**STRATEGIC PETROLEUM RESERVE  
ENGINEERING CHANGE PROPOSAL  
SUMMARY SHEET  
CLASS I CHANGE**

NUMBER: SJ-M/O-4656  
TITLE: Sugarland Terminal B.C. Static Mixer and Sampling System Installation

ECP NUMBER SJ-M/O-4656	ECP TITLE <b>Sugarland Terminal B.C. Static Mixer and Sampling System Installation</b>			PAGE 1 OF 6
CONTRACTOR CHANGE NO./REV.	INITIATED BY <b>Moises Martinez</b>	DATE <b>06/20/2013</b>	SUBMITTED BY <b>Kayode Olaniyi</b>	DATE <b>6/24/2013</b>
PRIORITY  <input type="checkbox"/> EMERGENCY  <input checked="" type="checkbox"/> URGENT  <input type="checkbox"/> ROUTINE	ORG./CONTRACTOR <b>Shell Pipeline Co.</b>	PHONE NO. <b>713-241-1850</b>	ORG./CONTRACTOR <b>Shell Pipeline Co.</b>	PHONE NO. <b>504-616-5490</b>
VALUE ENGINEERING  <input type="checkbox"/> VEP (MANDATORY)  <input type="checkbox"/> VECP (VOLUNTARY)		DRAWDOWN CRITICAL  <input type="checkbox"/> YES  <input type="checkbox"/> NO	ROM ESTIMATE  _____

CUSTOM 30" 3-ELEMENT MIXER		SHELL PIPELINE SUGARLAND TERMINAL SUGARLAND METERING DEBOTTLENECK	
PROJECT NO.	CAD FILE NO.	DRAWN BY	CHECKED BY
11A1101	11A1101-550	JRM	HAK
		DESIGNED BY	APPROVED BY
		DATE	CLIENT'S DWG. NO.
		06/12/13	
		SCALE	SHT. NO.
		NONE	550
			REV. 0

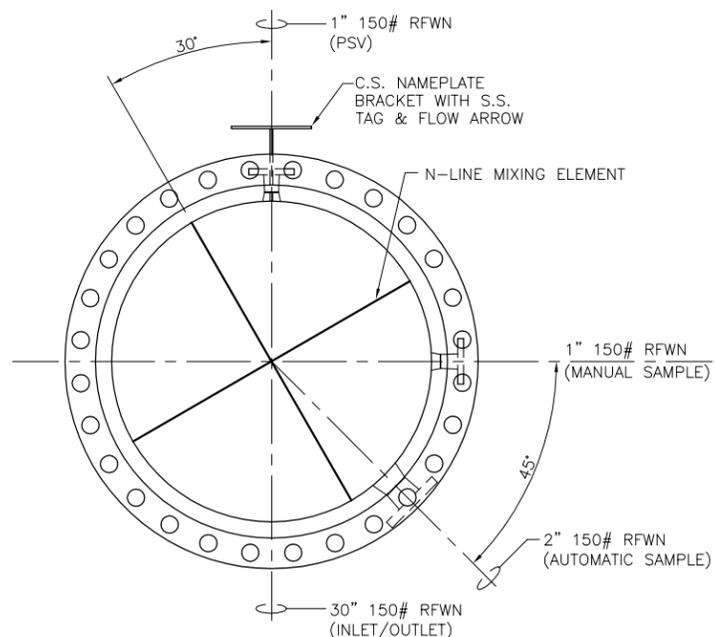
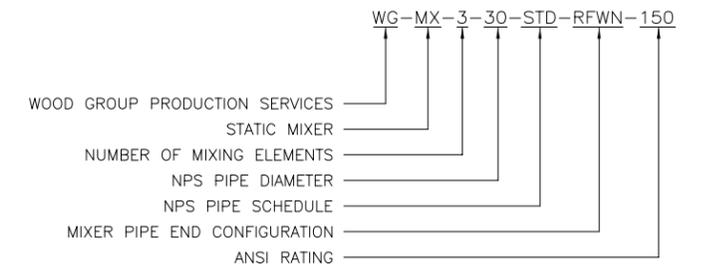
- Installation of one 30" Triple Element static mixer with flange for sampler and manual sample port
- Installation of one C-22-26 ext with CD-20B motor
- Three 5 gallon sample containers
- Two 15 gallon sample containers
- Five valves and CI DII actuators for sample pot select
- Installation of isolation valve for sampler
- Installation of one Manual sample probe and valve
- Installation of all required electrical conduit runs and wiring

BAYOU CHOCTAW METERING STATION

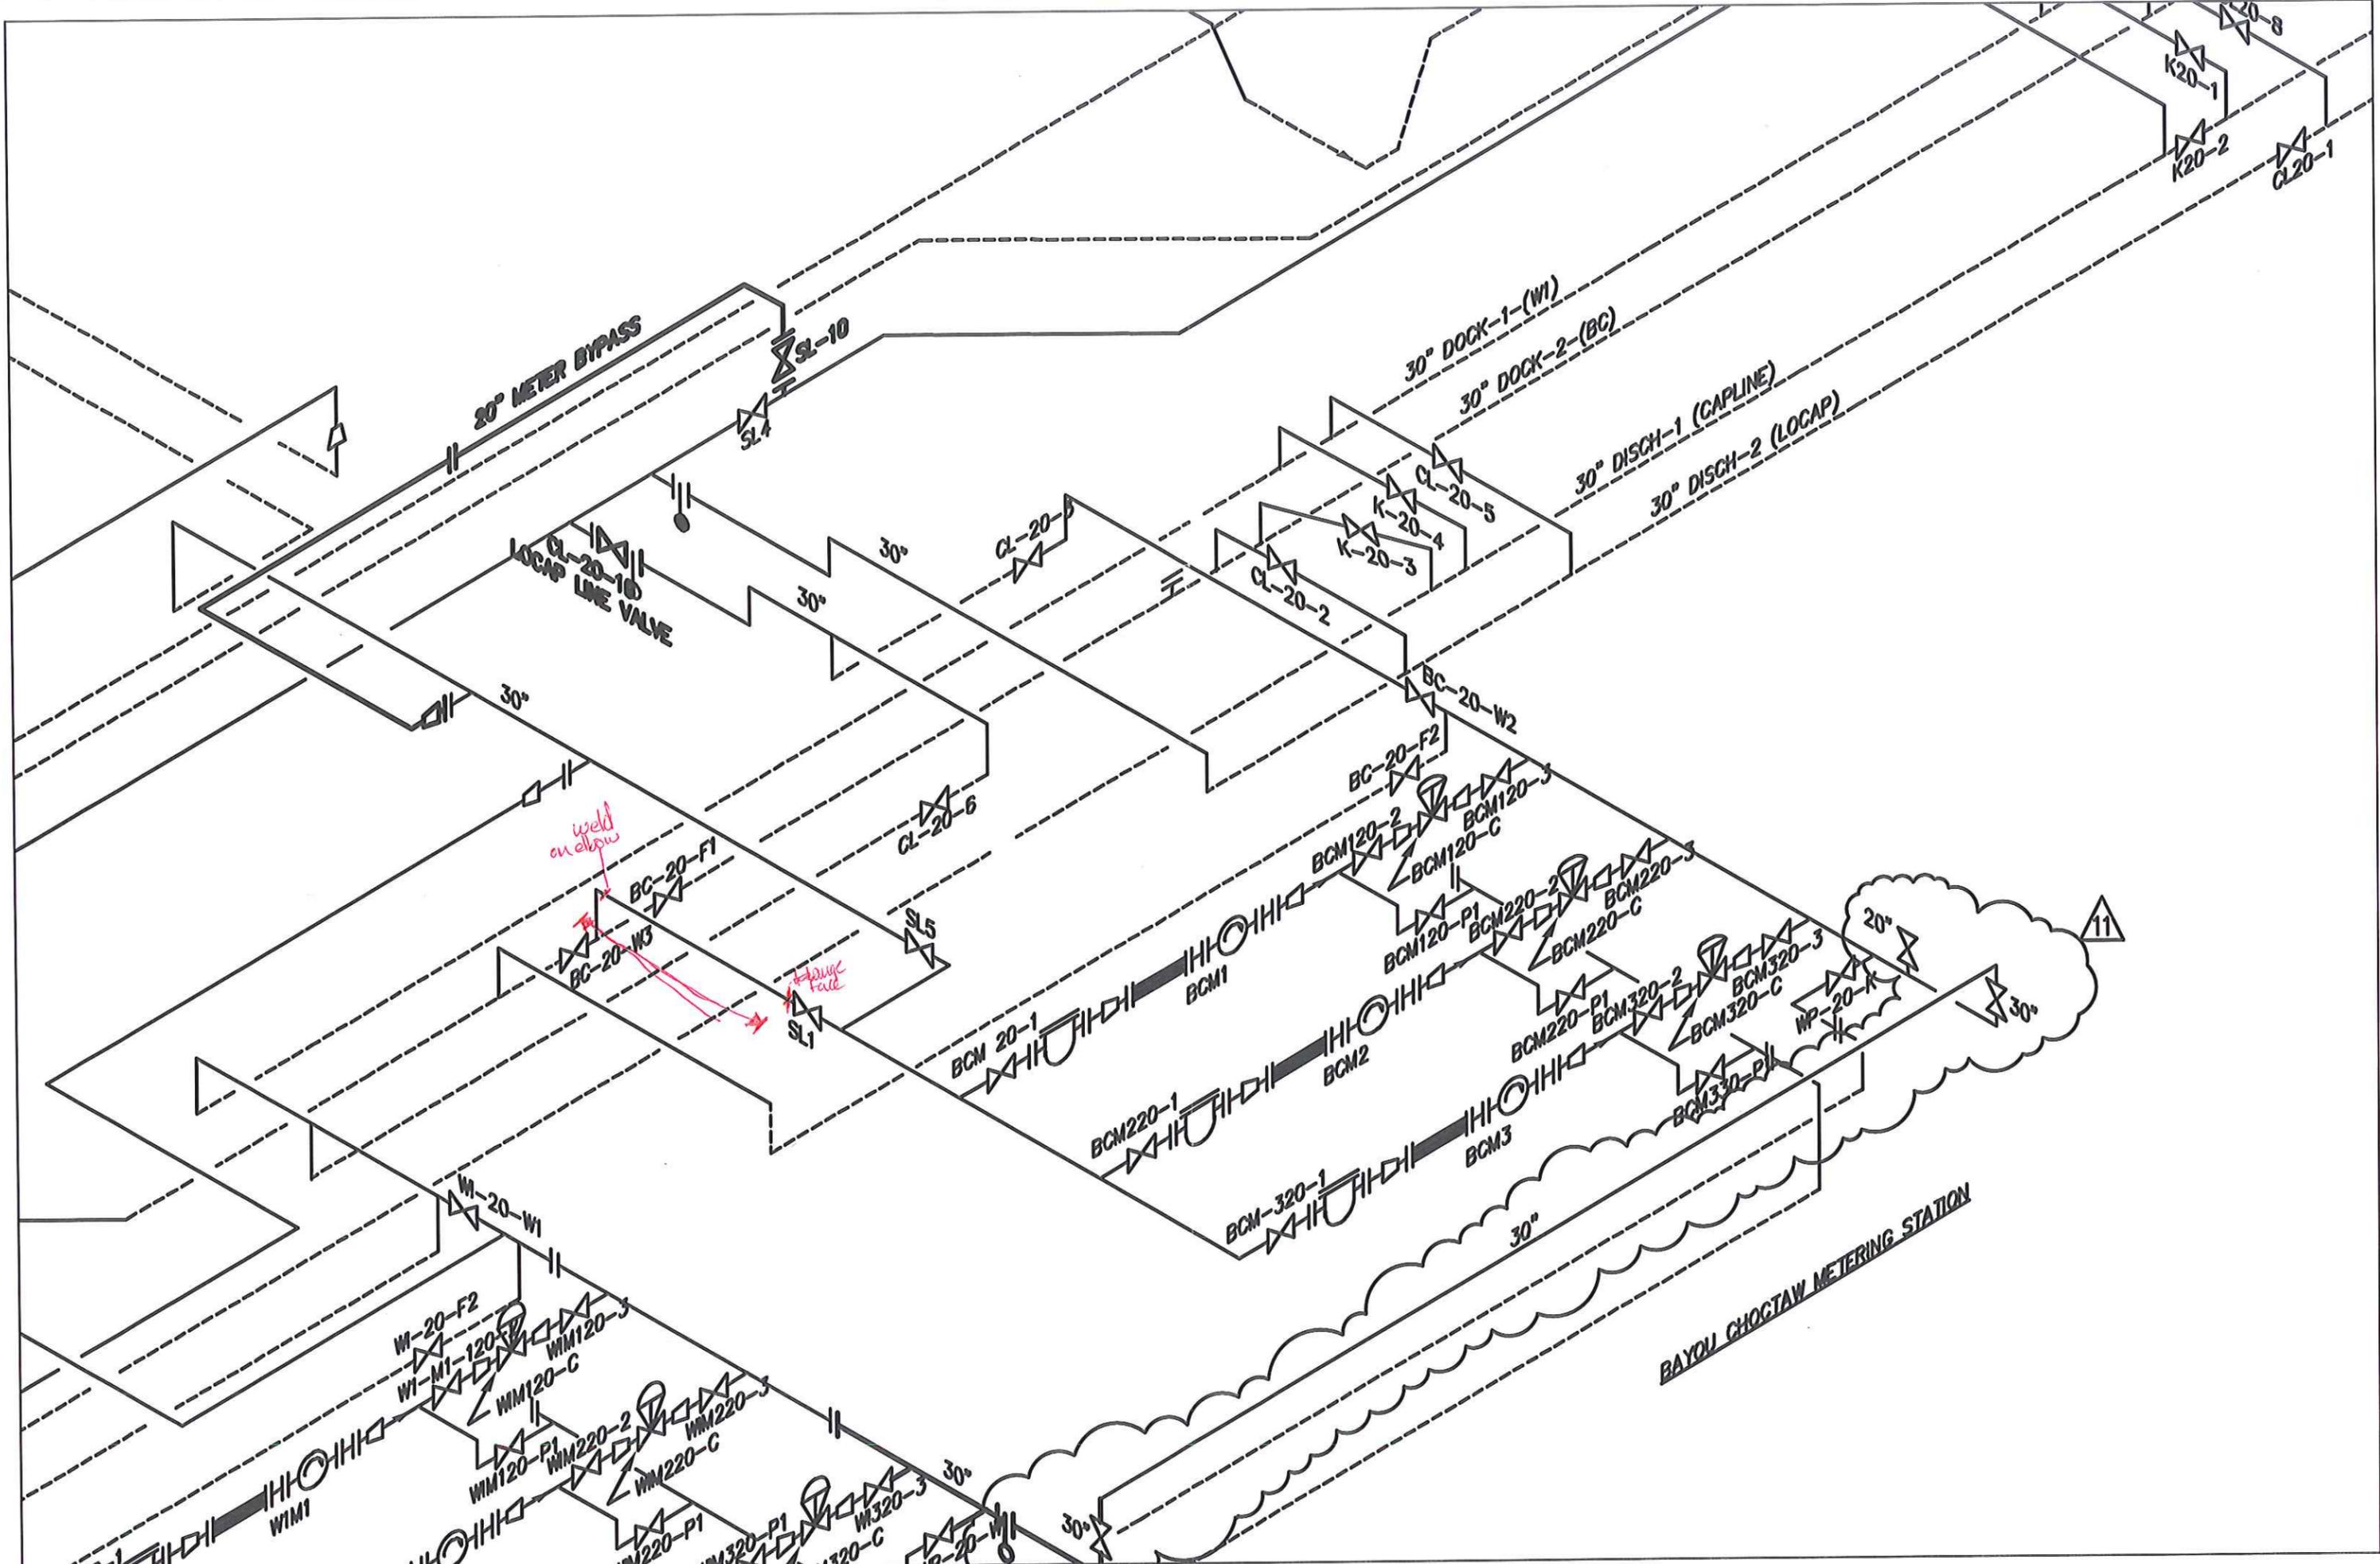
→ Bayou Chodrau  
 Refers

weld on elbow

tearout face
